MASTER DEVELOPMENT DRAINAGE PLAN AMENDMENT
FOR
WATerview EAST
&
PRELIMINARY DRAINAGE PLAN
FOR
TRAILS AT ASPEN RIDGE

August 2019

Project No. 19.866.008

Detention Basin Outlet Structure Design

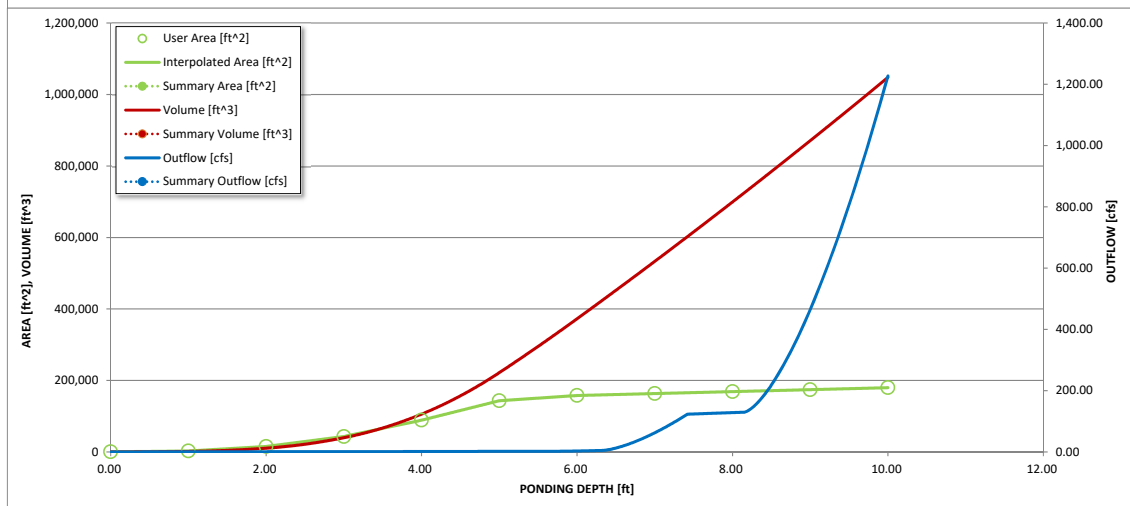
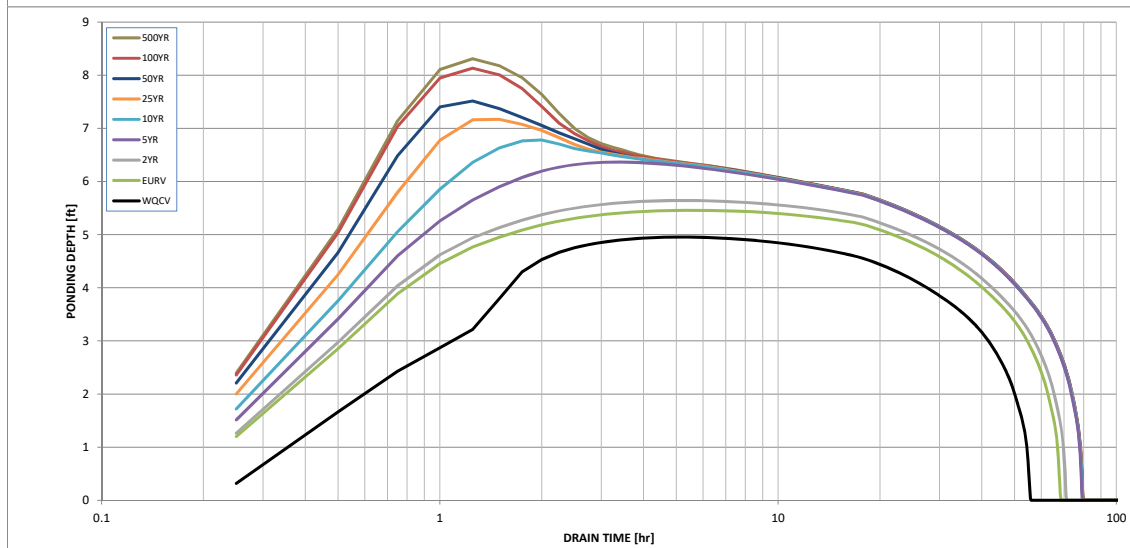
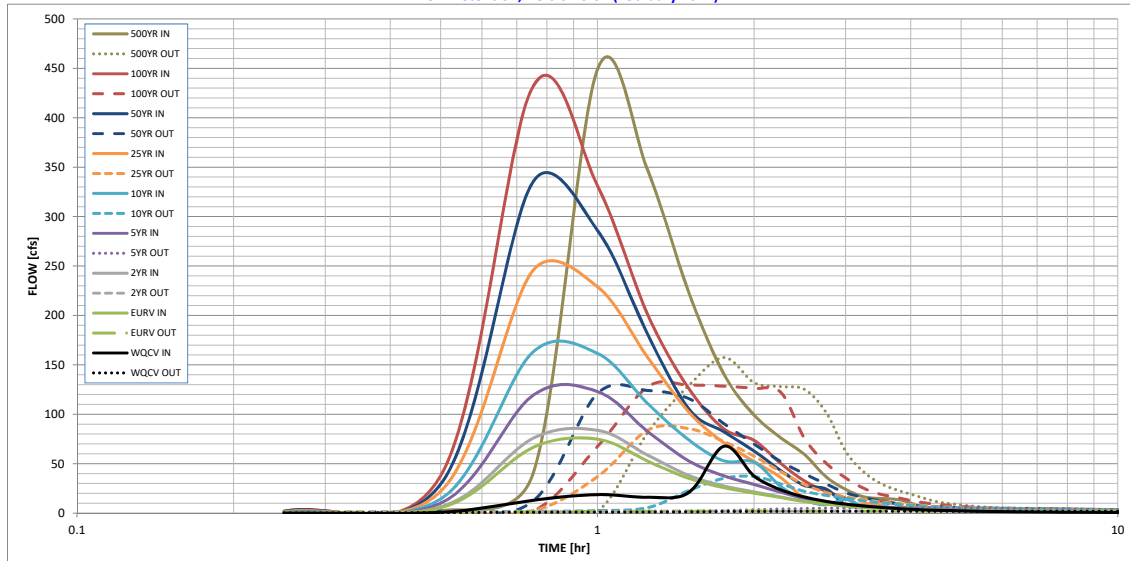
Be advised: Time to drain needs to be around 40hrs in the final drainage report.

DESIGNED BY: JTS	SCALE:	DATE ISSUED: AUGUST 2019	DR-02
CHECKED BY: JTS	HORIZ. VERT.	SHEET NO. 2 OF 2 SHEETS

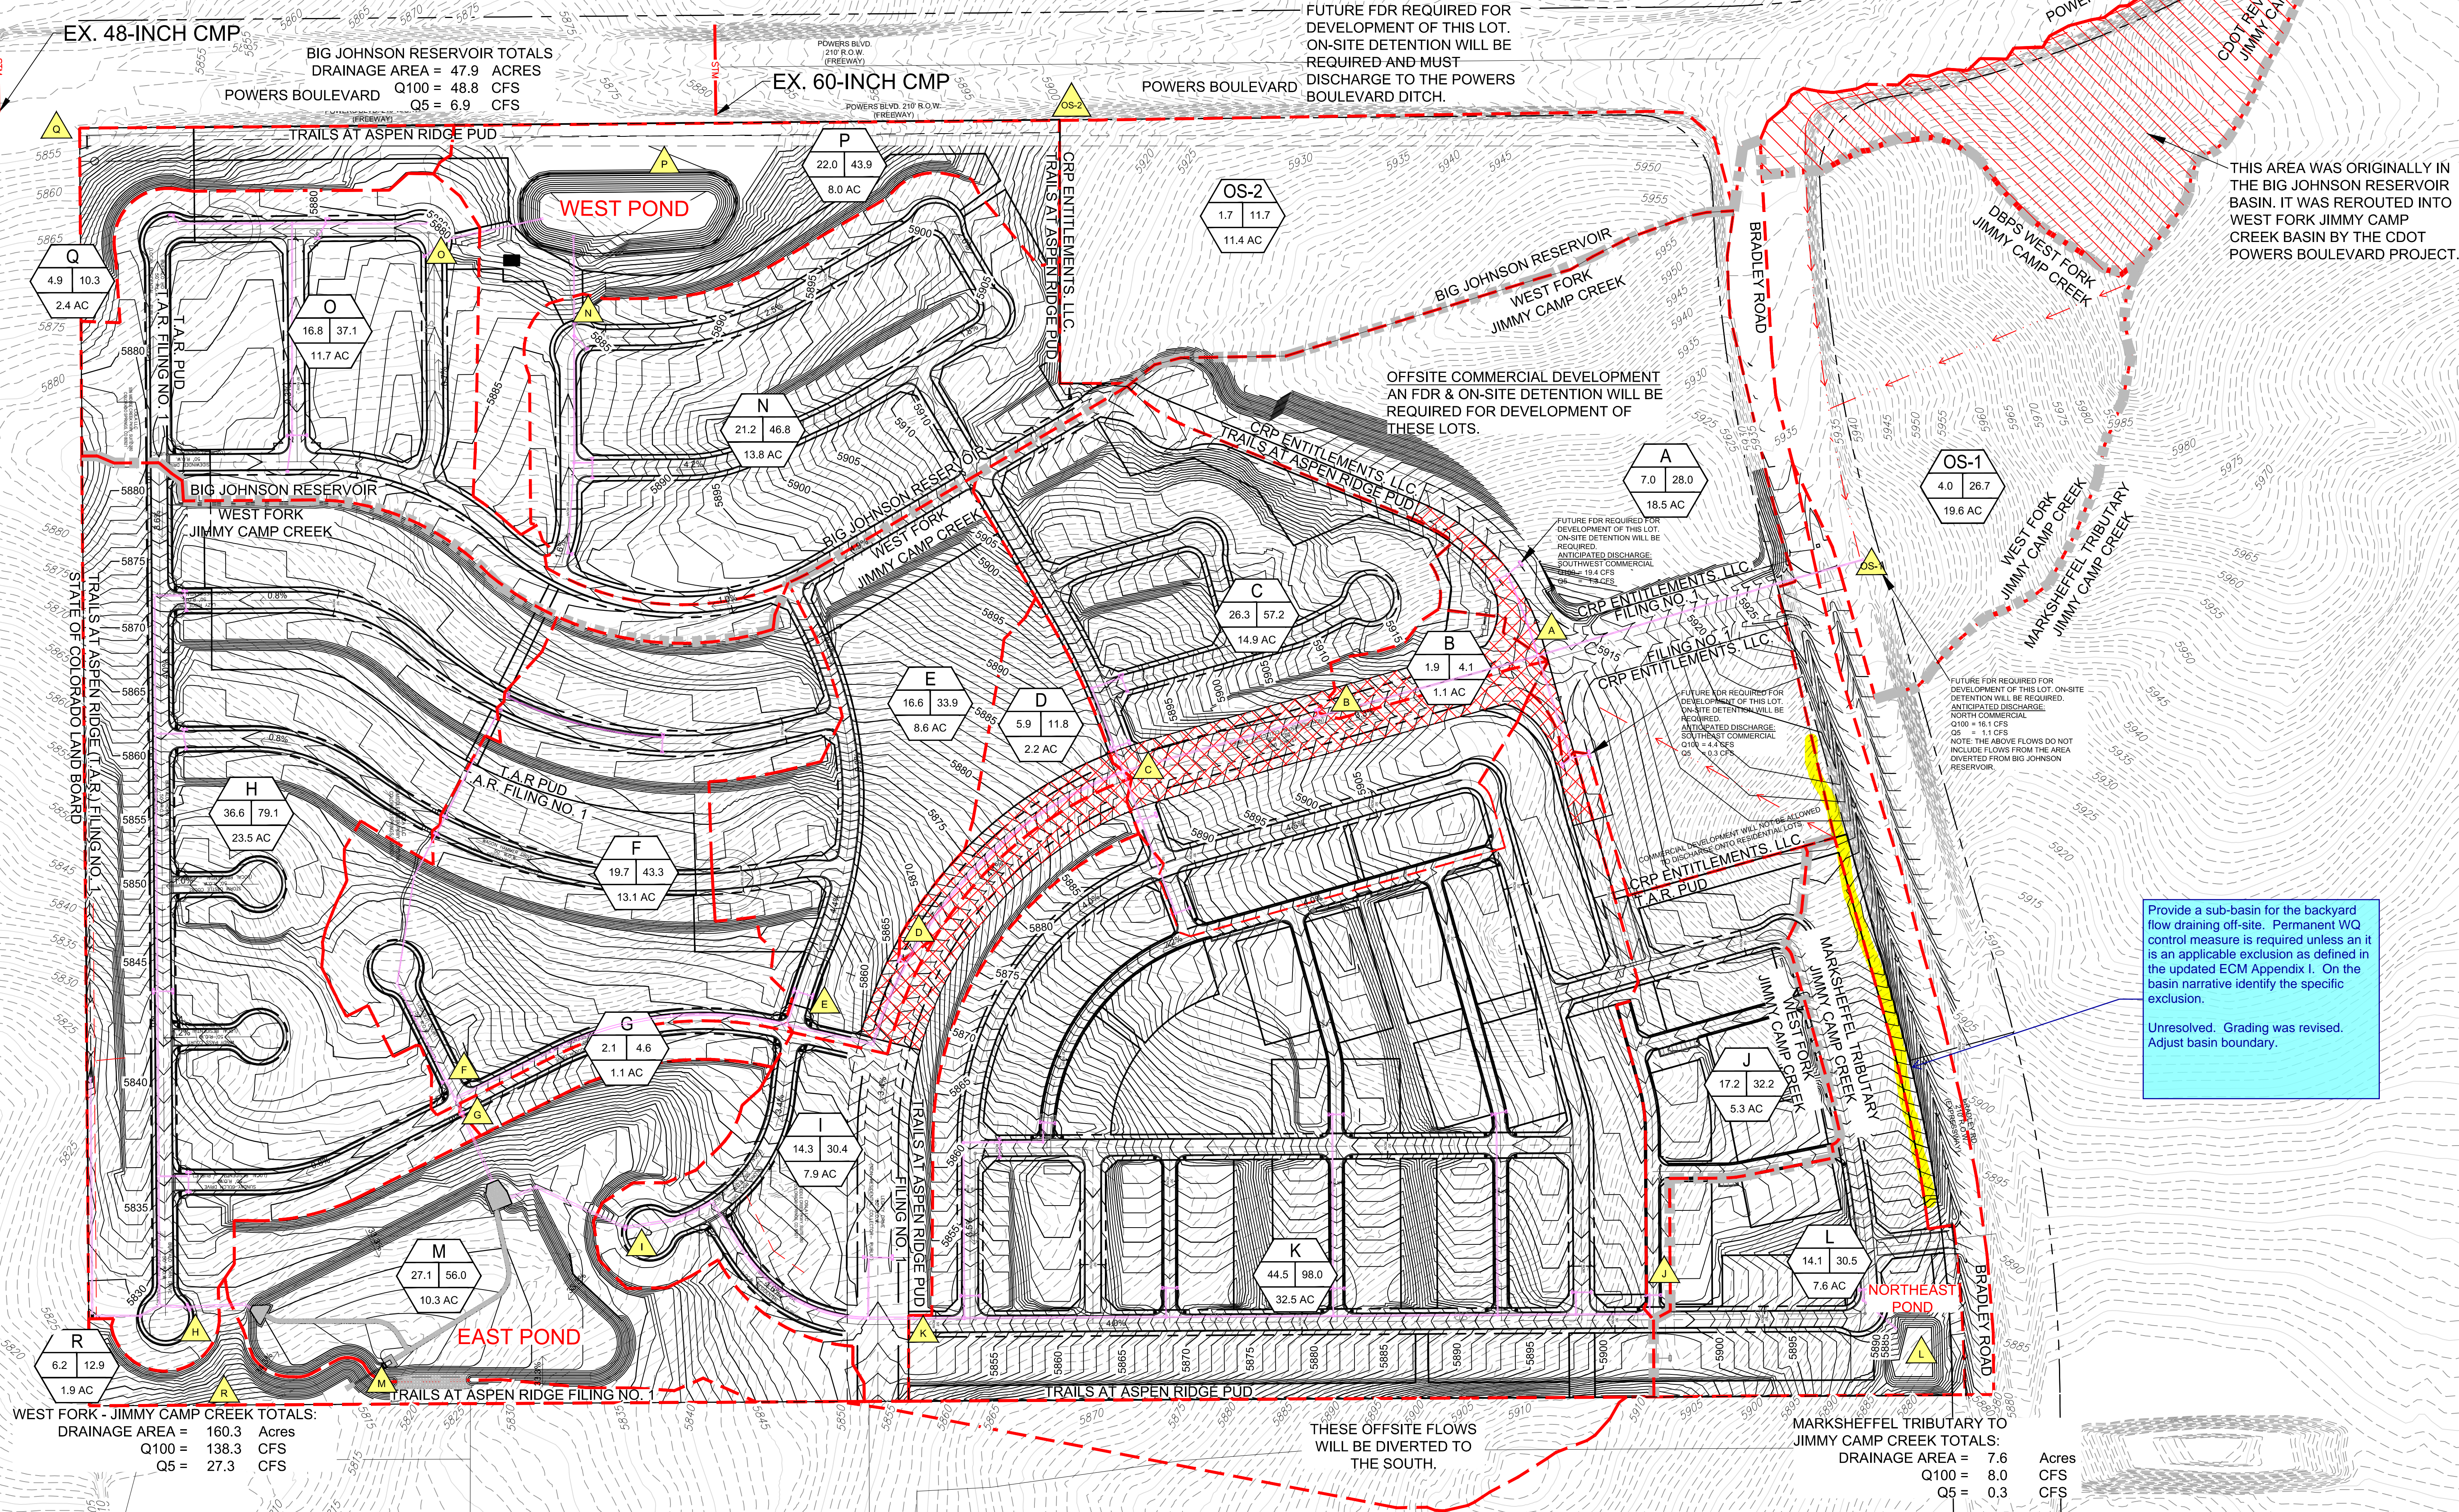
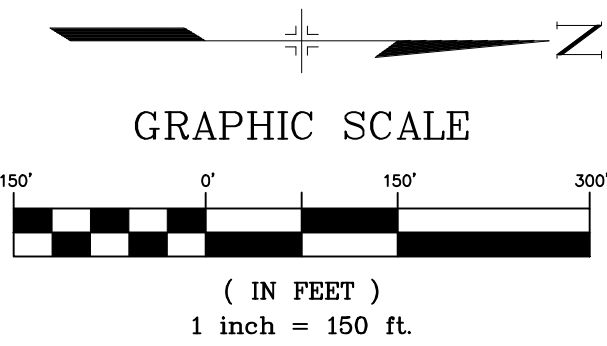
Provide a sub-basin for the backyard flow draining off-site. Permanent WQ control measure is required unless an it is an applicable exclusion as defined in the updated ECM Appendix 1. On the basin narrative identify the specific exclusion.

Unresolved. Grading was revised. Adjust basin boundary.
